# SERVICE BULLETIN

AN16-013B
 NTB16-034B
 March 12, 2021

# 2015 MURANO; BUZZ NOISE FROM SPEAKERS WHEN SEAT CLIMATE CONTROL HEATER TURNED ON

APPLIED VEHICLE: 2015 Murano (Z52)

Figure 1

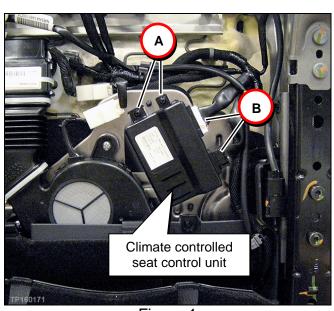
A buzz noise coming from the speakers when:

The driver seat climate control heater is turned ON.

The passenger seat climate control heater is turned ON.

Replace the climate controlled seat control unit.

A = Screws

B = Harness Connectors

- Replace the control unit only for the seat that is making the buzz noise.
- Refer to the Electronic Service Manual (ESM), section SE-Seat, for replacement information.
